City of North Miami Beach, Florida

ADDENDUM NO. 5

SUBJECT: **PROVIDE GENERATOR AND FURNISH ALL MATERIALS, LABOR, EQUIPMENT, TOOLS AND INCIDENTALS TO INSTALL THE GENERATOR AND COMPLETE THE CITY HALL GENERATOR REPLACEMENT PROJECT**

BID NUMBER: **#2009-05**

SHEET NO. E-03

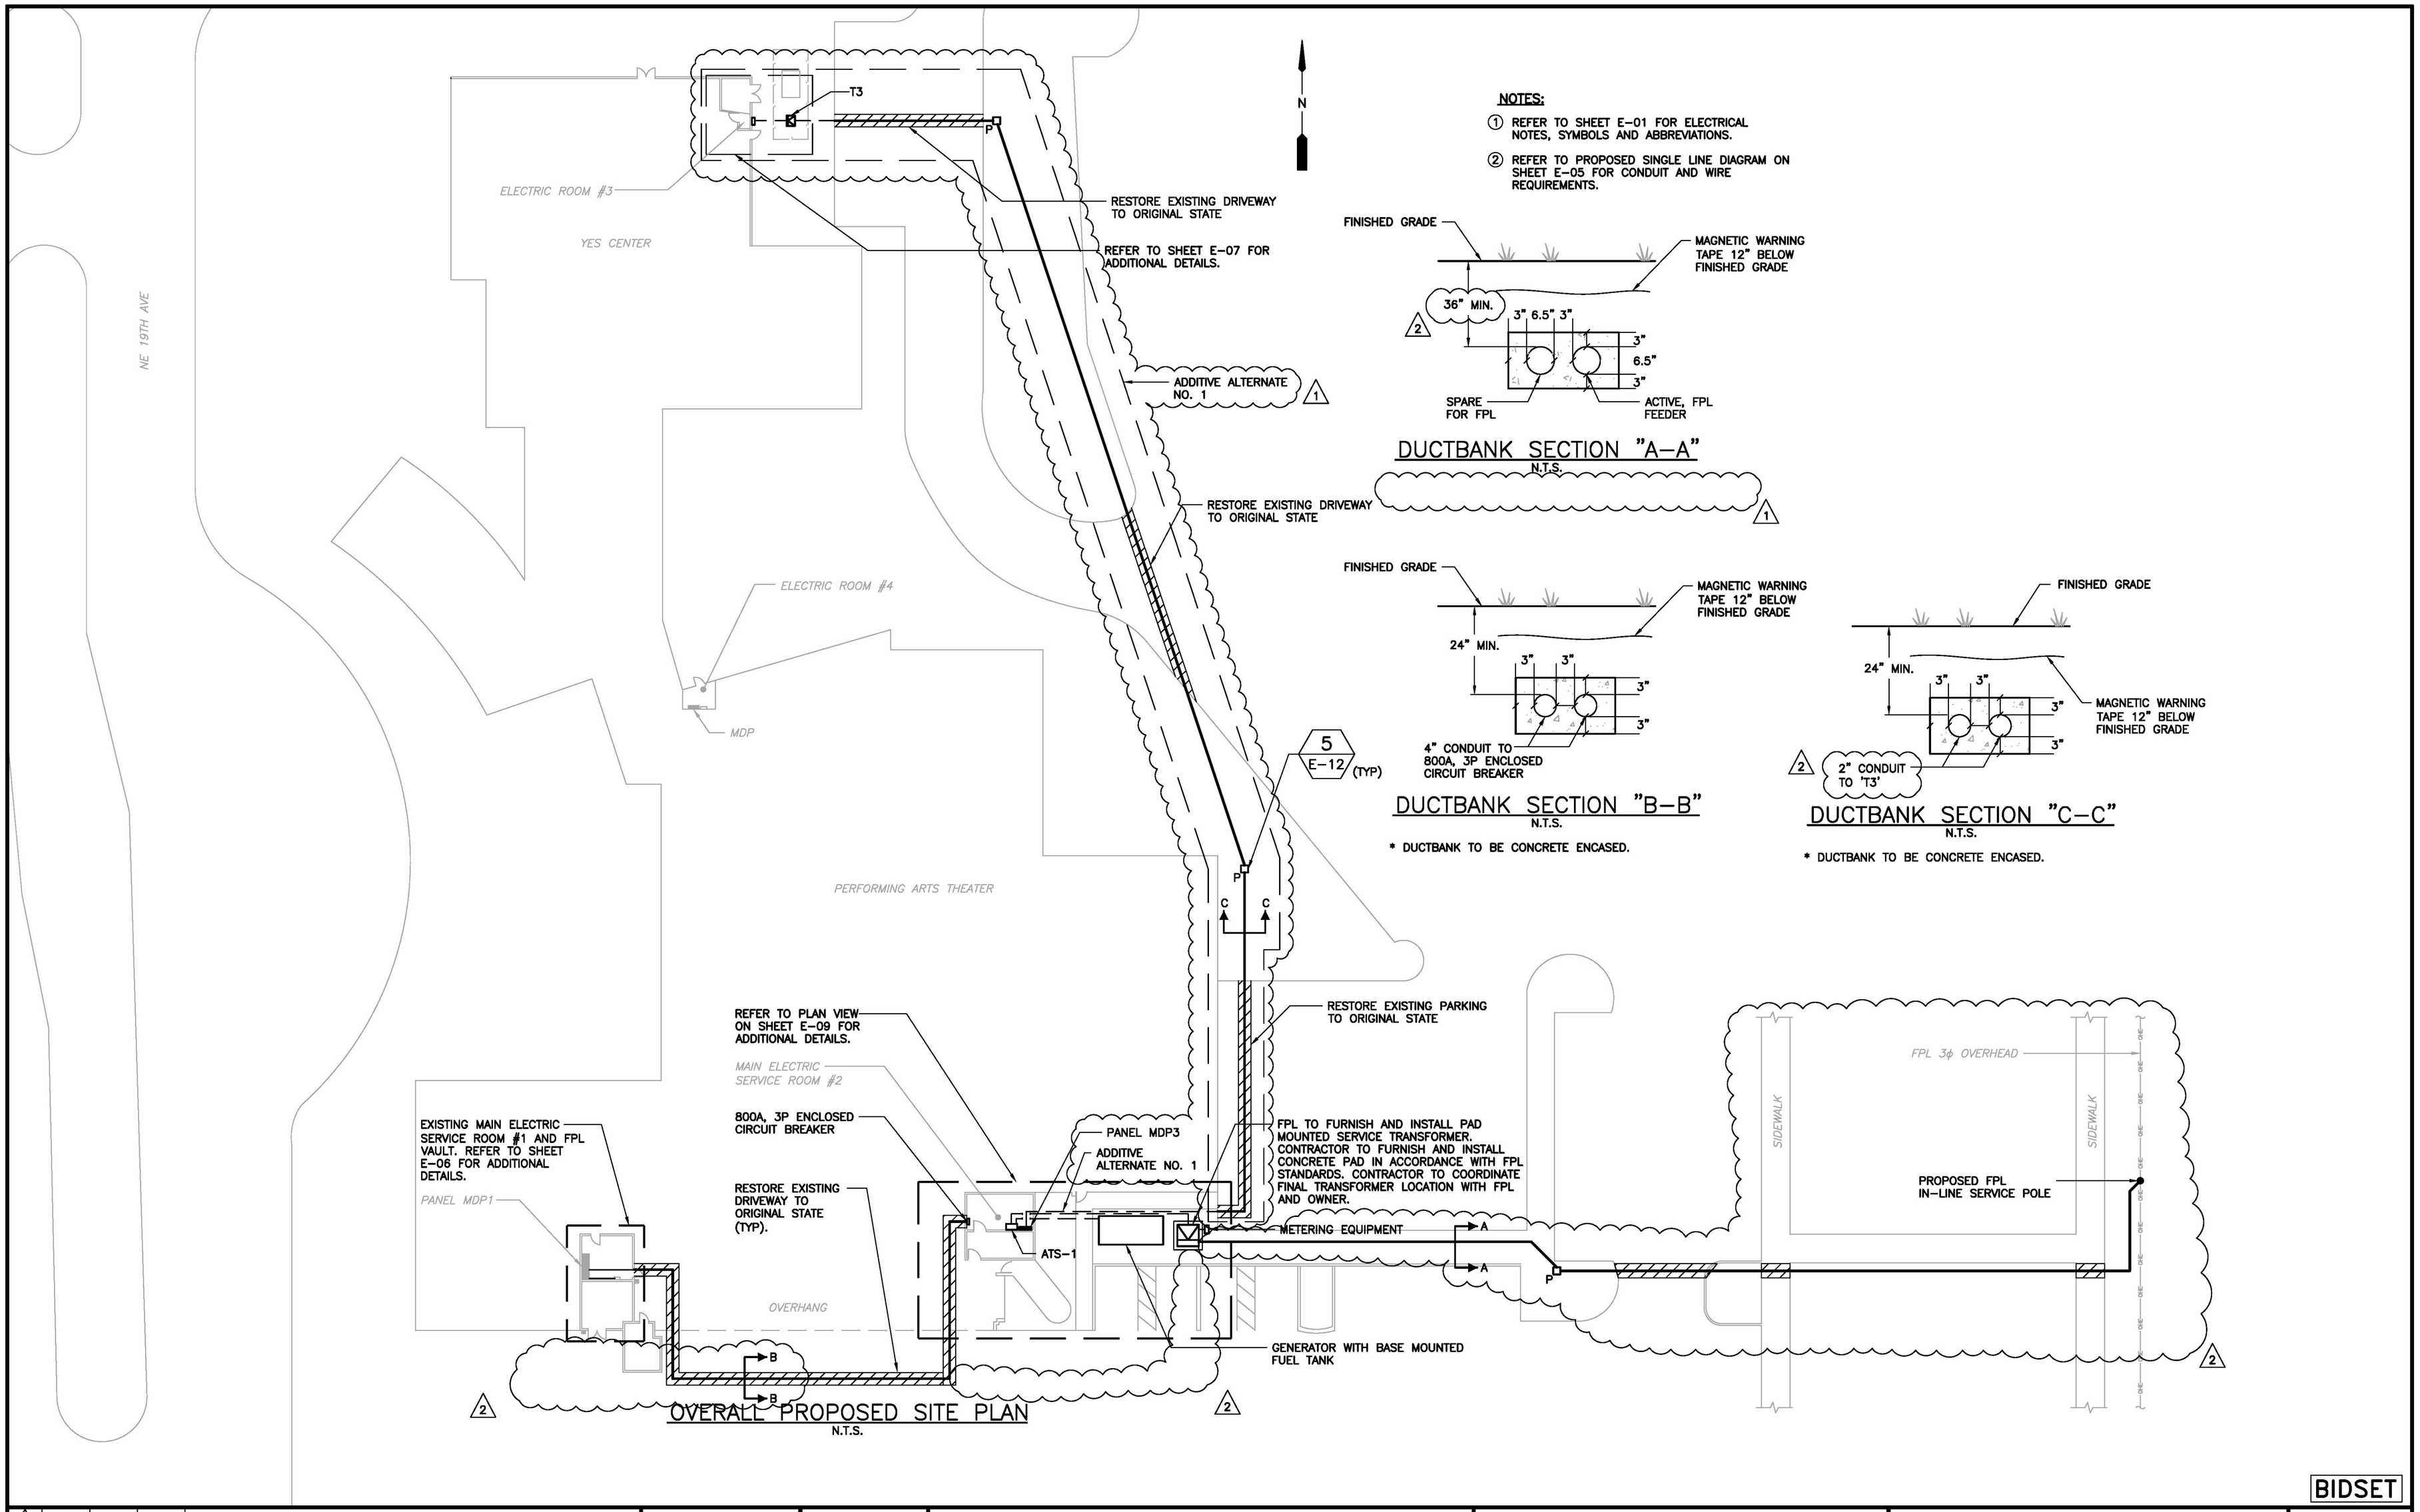
Comment No. I E-02 and E-03 still do not have a scale on them. We need scale of drawing for measurement of conduit runs.

Comment No. 2 Is F.P.L. to supply & install new manhole at location of service feeder intercept sheet E-03 site plan?

Response No. 1 Scale shall be 1"=20'-O" for Sheets E-02 and E-03 (24" x 36" Plans). Provide an additional 20% linear feet when measuring conduit and wire runs on sheets E-02 and E-03.

Response No. 2 New manhole shall be furnished and installed by Contractor. Refer to detail on sheet E-12.

SHEET NO. E-05

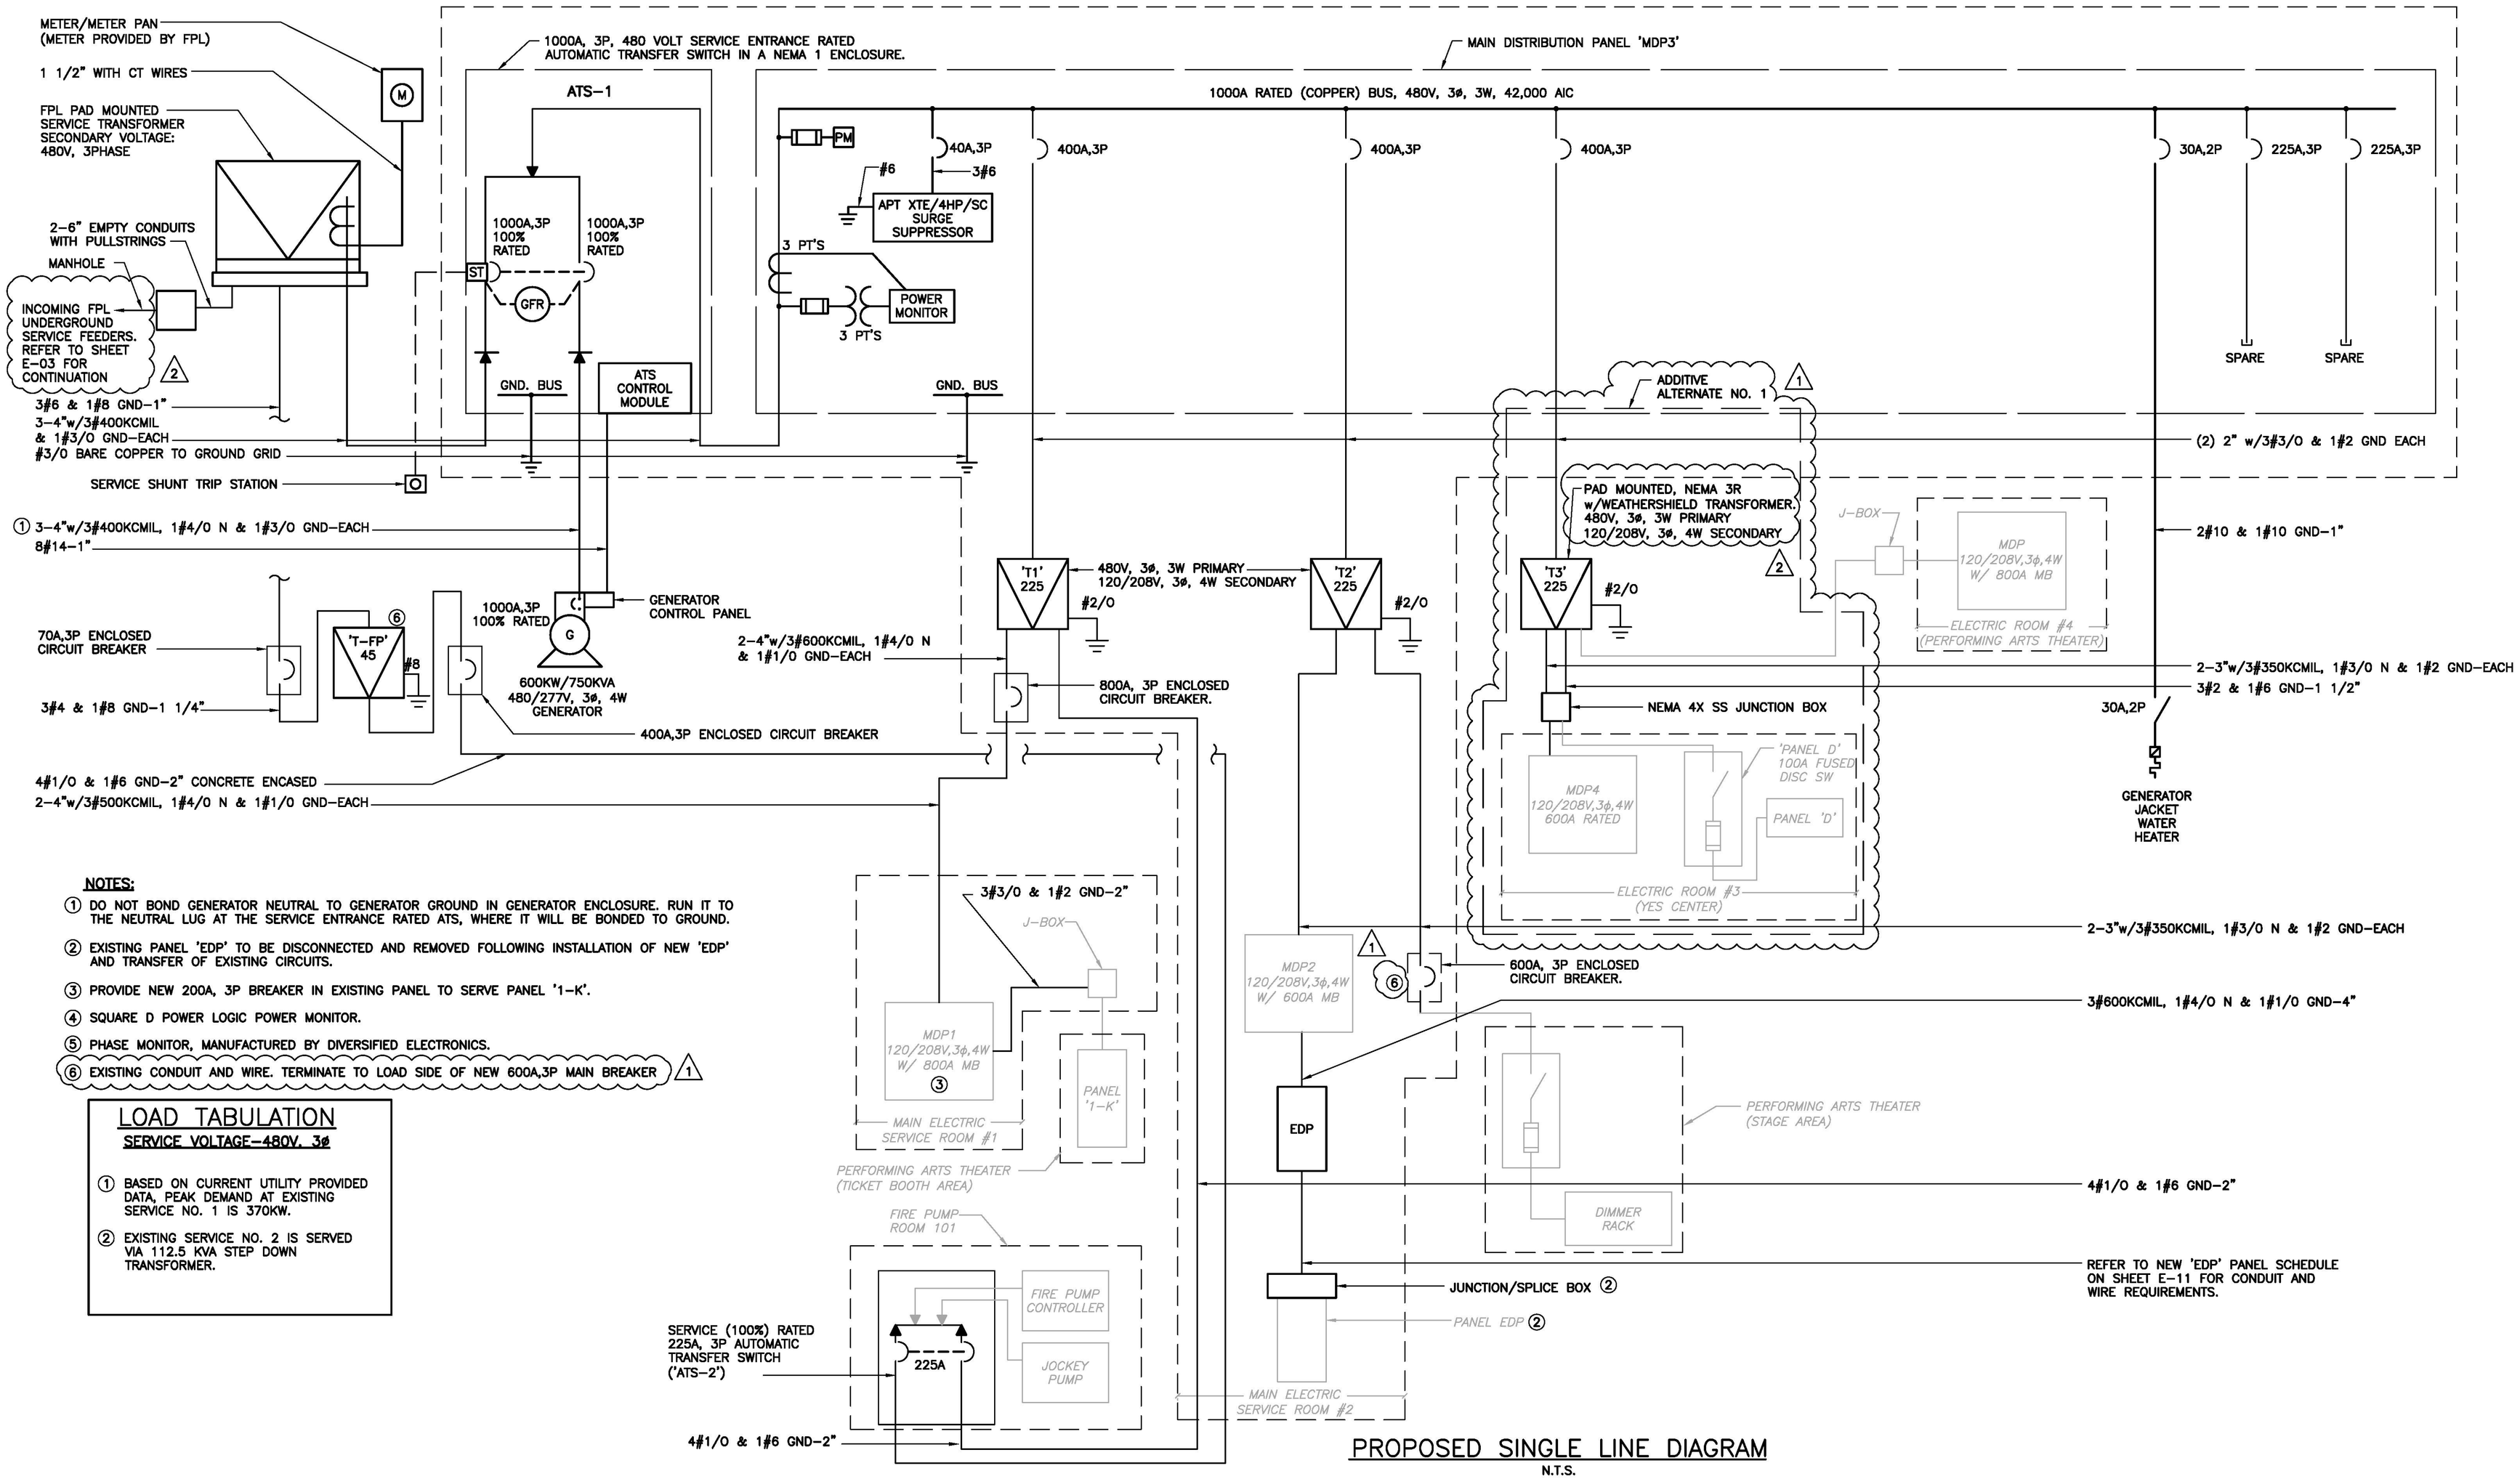
Comment No. I Transformer T3 on sheet E-05 shows to be liquid filled (could you provide manufacturer & specification on this item?) Also, TI & T2 are the same size & voltage. Are these 2 dry type transformers?

Comment No. 1 Re: Alt #1 Ductbank section D-D shows two - 4" conduits for T-3 from panel MDP3. Sheet F-OS single line diagram shows 2 - 2" with 3 - 3/0 and I - #2 each, for T-3. Also duct bank F-F on sheet E-O9 shows only I - 4" conduit for T-3. Which is correct?

Response No. 1 T-3 shall be a dry type pad mounted transformer rated NEMA 3R with weathershield. Ti & 12 shall be dry type transformers.

Response No. 2 Sheet E-05 single line diagram is correct. It should be two (2) 2" conduits.

SHEET NO. E-09

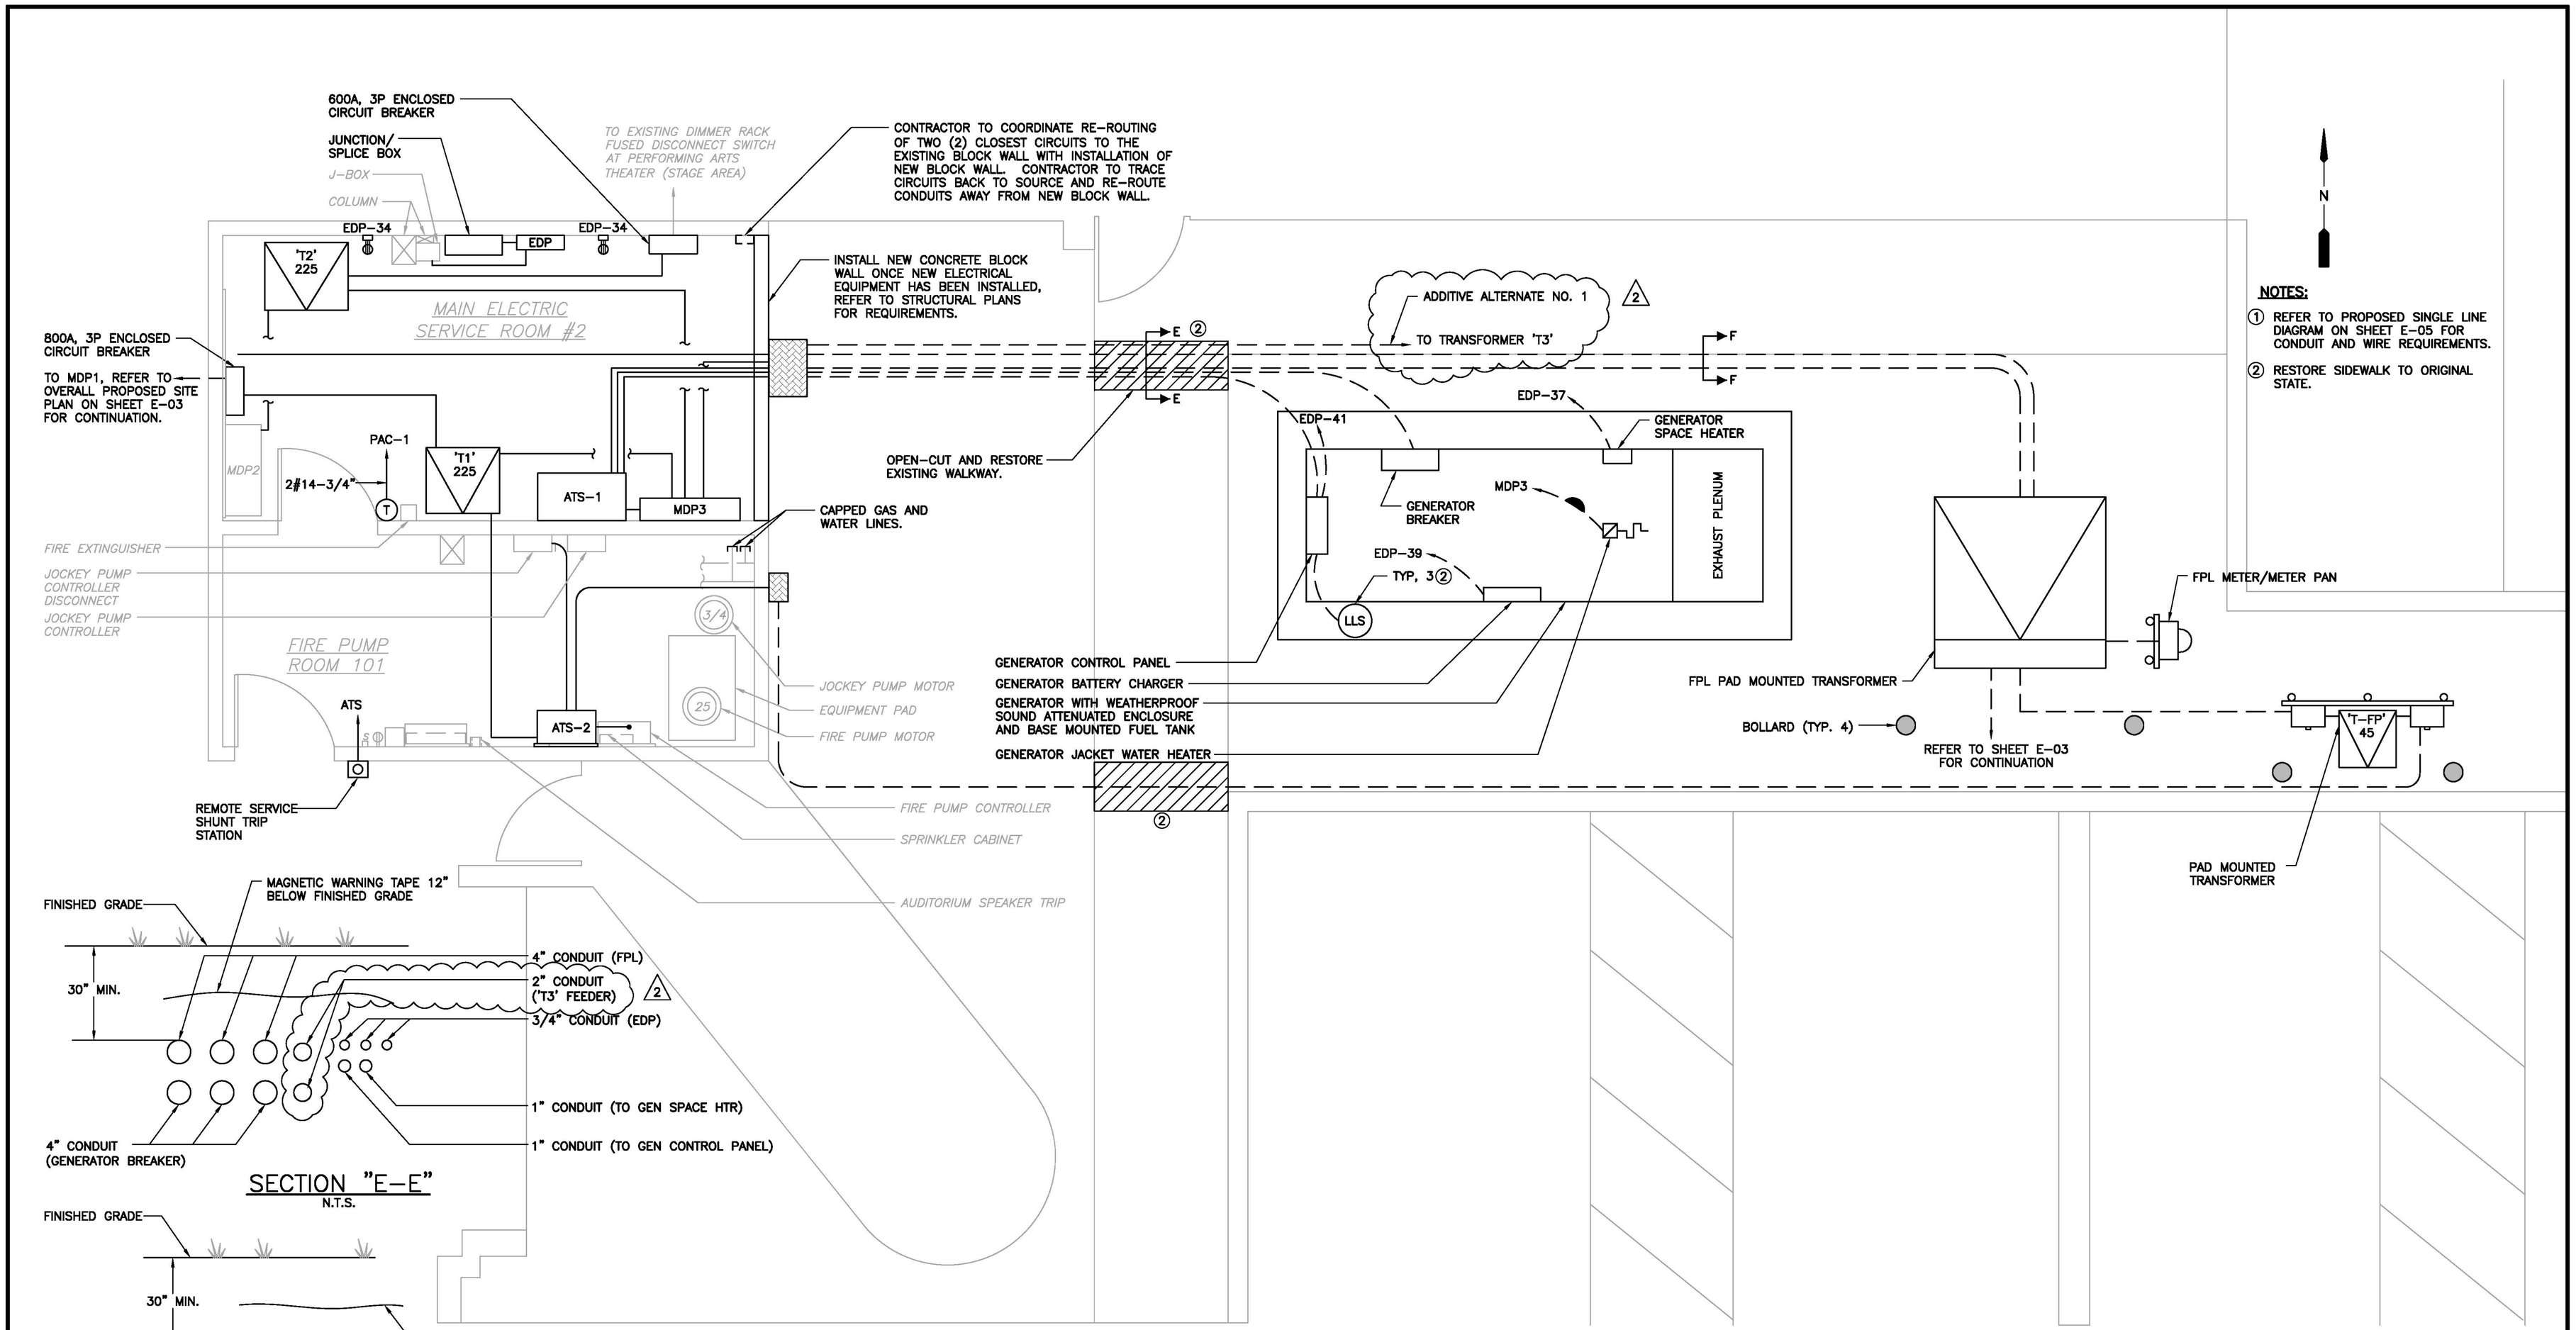
Comment No. 4 Sheet F-09: Is it the intent that the feeders from the new generator to electric room #2 be installed under the existing floor slab or can they be installed exposed on outside of new wall and routed overhead in electric room #2? Also, the bonding of electric room #2 can that be installed exposed within electric room #2 and not underground as shown?

Comment No. 2 Please review sheet E-09 duct bank F-F section. The feeder for T3 should show as well.

Response No. 4 Exterior conduit from the new generator to existing Electric Room No. 2 shall be installed underground, then exposed wall mounted exterior to Electric Room No. **2. Conduit internal to existing** Electric Room No. 2 shall be installed exposed and overhead. Grounding internal to electric room #2 shall be installed in 1" schedule 40 PVC exposed conduit.

Response No. 2 Refer to revised sheet E-09 issued in this addendum. Iwo (2) 2" conduits have been added.
